# Access Compliance Report

## Public Rights-of-Way

Intersection ID: 13156	Main Street: S_TRYON_ST	Cross Street: W_CARSON_BV	Location: N
ADA ID: FC334A177406	Ramp Type: PerpDiag	Initial Pass/Fail: Fail	Overall Compliance: No
			Severity Score: 21.25

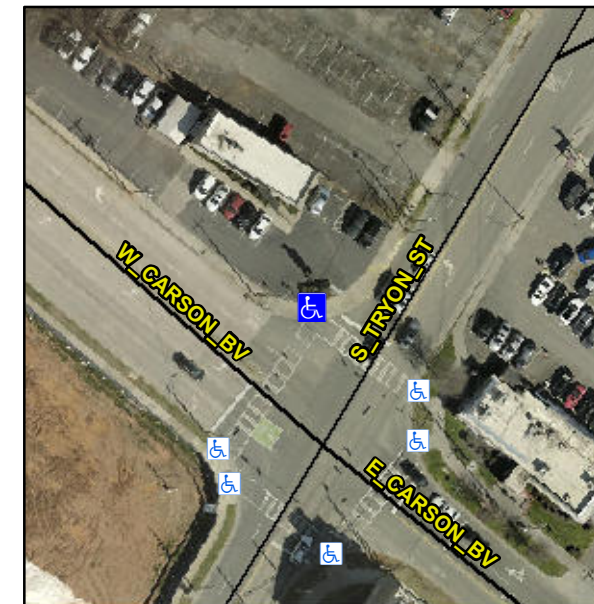
**Not Found, R304.5.1, R304.2.2**

Compliance	Description	Data	Compliance	Description	Data
N/A	Ramp Length (in)	85.0	No	Ramp Slope (%)	9.0
No	Ramp Width (in)	40.5	Yes	Ramp XSlope (%)	0.5
N/A	Flare Type LT	N/A	N/A	Flare Type RT	N/A
N/A	Flare Slope LT (%)	N/A	N/A	Flare Slope RT (%)	N/A
N/A	Flare Traversable LT?	N/A	N/A	Flare Traversable RT?	N/A
N/A	Landing Length (in)	N/A	N/A	DWS Provided?	N/A
N/A	Landing Width (in)	N/A	N/A	DWS Contrast?	N/A
N/A	Landing Slope (%)	N/A	N/A	DWS Length (in)	N/A
N/A	Landing X Slope (%)	N/A	N/A	DWS Full Width?	N/A
N/A	Landing Curb? (Y/N)	N/A	N/A	DWS Offset (in)	N/A
N/A	Shared Landing?	N/A			
N/A	Gutter Ponding?	N/A	N/A	Gutter Slope (%)	N/A
N/A	Gutter Lip Ht (in)	N/A	N/A	Gutter X Slope (%)	N/A
N/A	Painted X Walk1?	Yes	N/A	Painted X Walk2?	Yes
	X Walk 1 Direction	To SW		X Walk 2 Direction	To SE
N/A	X Walk 1 Width (in)	100.0	N/A	X Walk 2 Width (in)	111.0
	X Walk 1 Slope (%)	2.0		X Walk 2 Slope (%)	0.6
	X Walk 1 X Slope (%)	0.9		X Walk 2 X Slope (%)	0.0

**Remove & Replace Curb Ramp With Two New Directional Ramps or Equivalent.**
